# Building Permit Application

Permit No.: B14002008

**RE: B14002008  
5003 Crape Myrtle Court  
Ellicott City, MD 21042**

**OPT. ALTERNATE LOWER FLOOR PLAN**  
CLIENT REFERENCE: **CRAFTMARK HOMES / KENWOOD II**

OPT. ALT. UPPER FLOOR W/ ALT. FLOOR PLAN

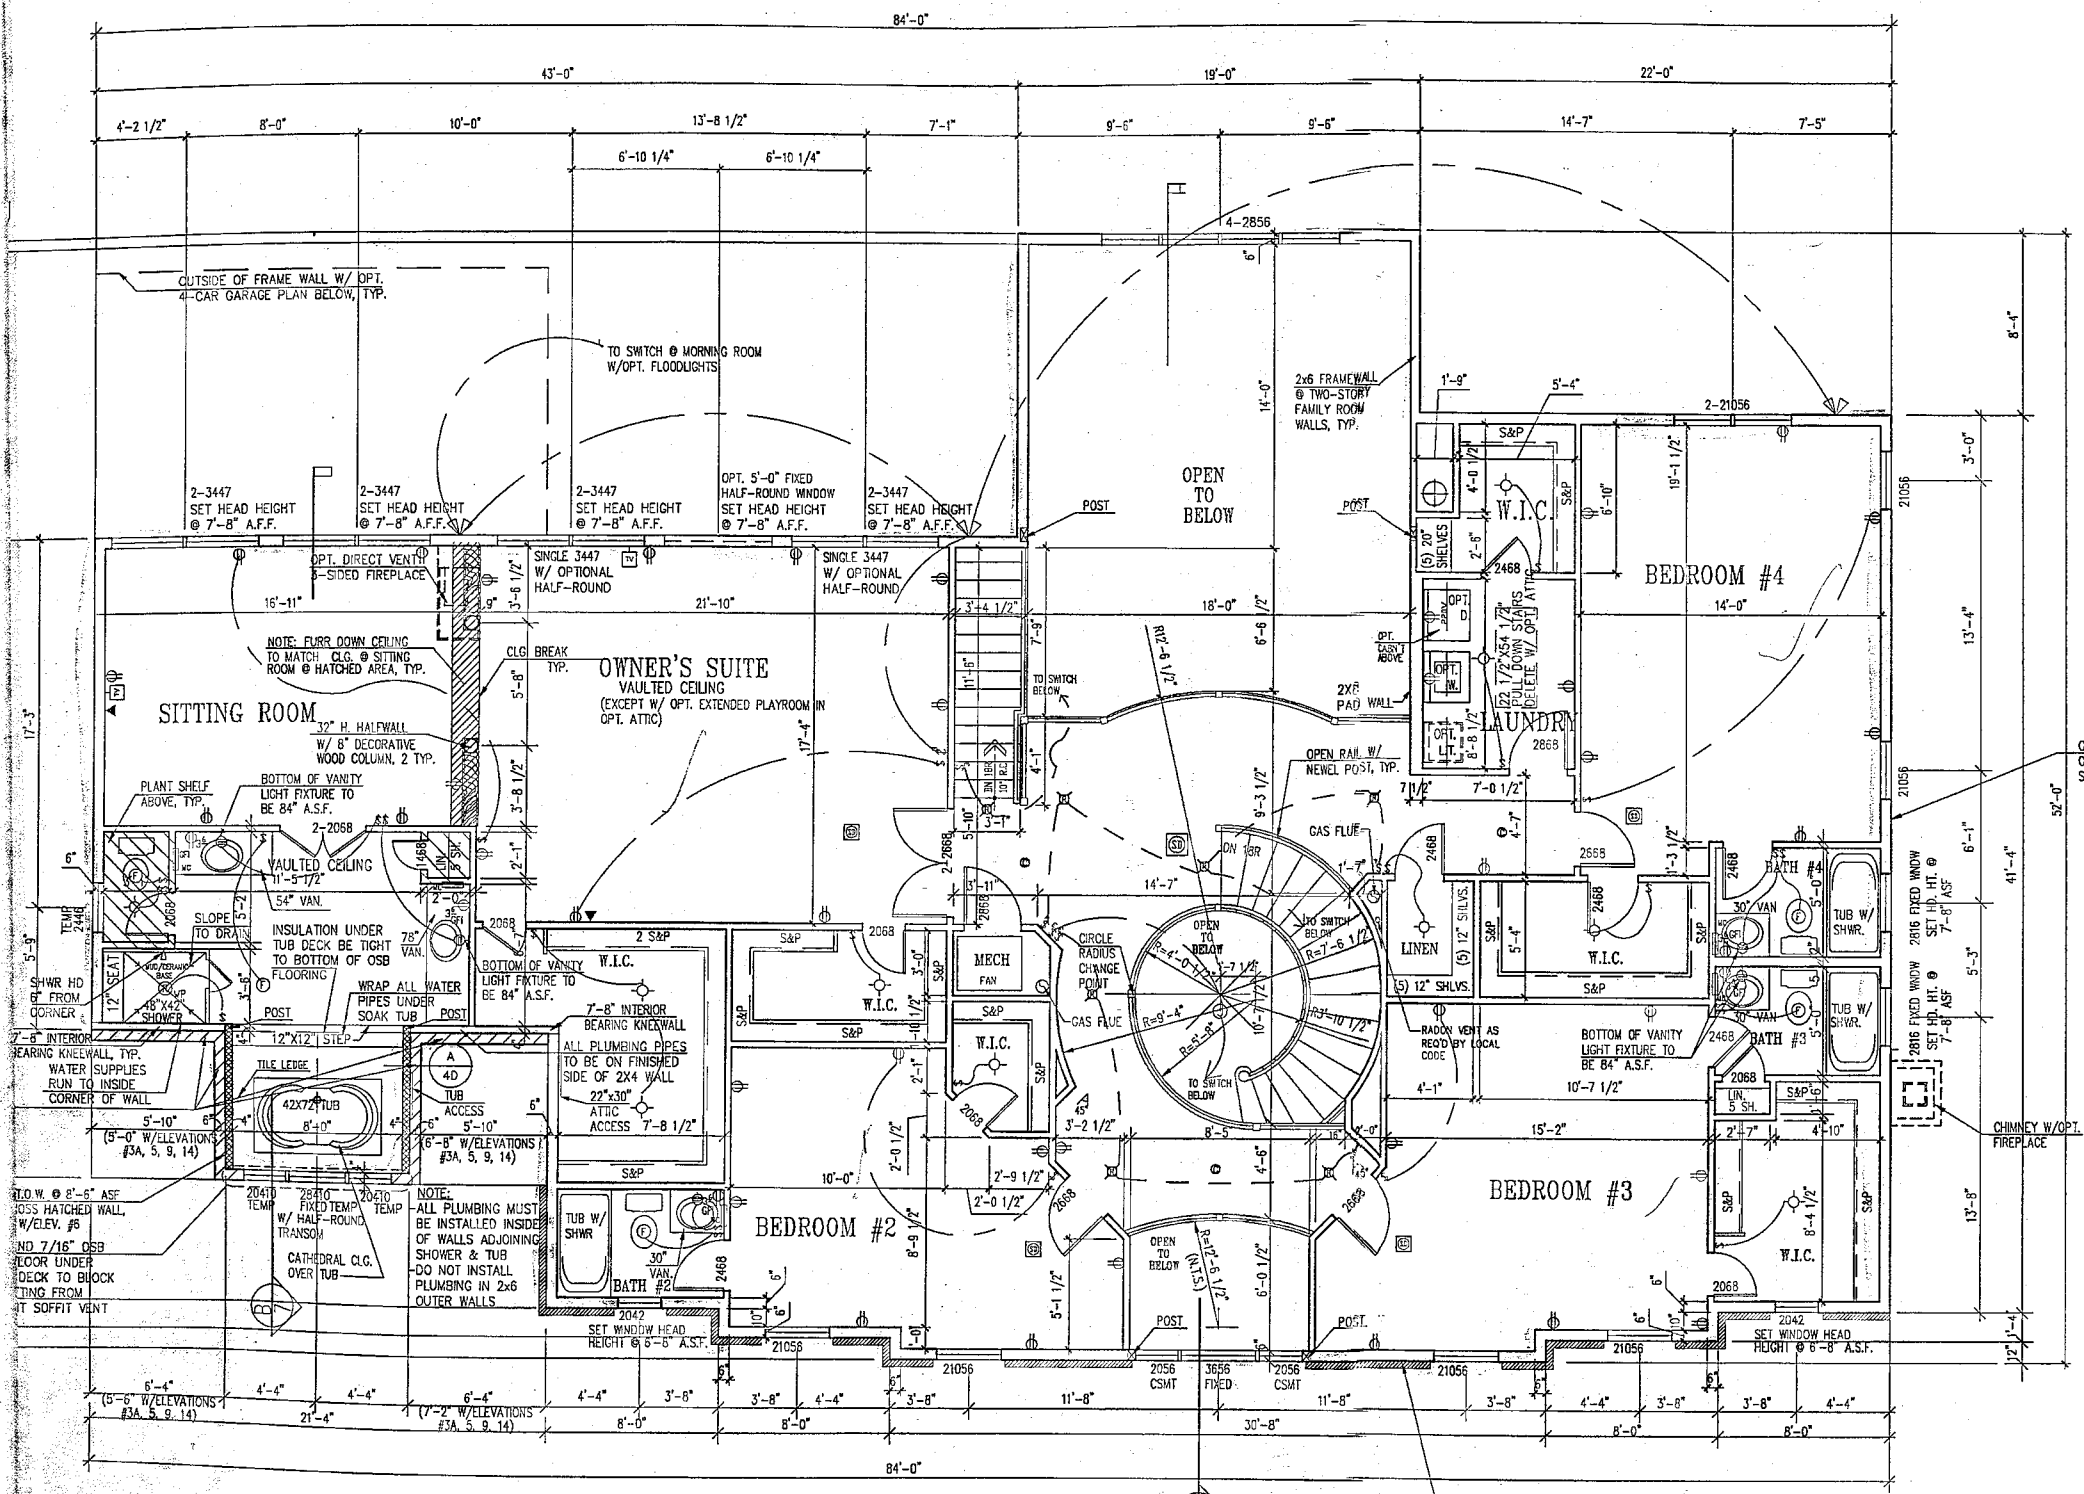
This letter is in response to building permit B14002008. The floor plan for this project shows 5 bedrooms which is the maximum bedroom capacity for this site. If the full bath in the attic is roughed-in, it cannot be finished without first converting an existing bedroom into something else.
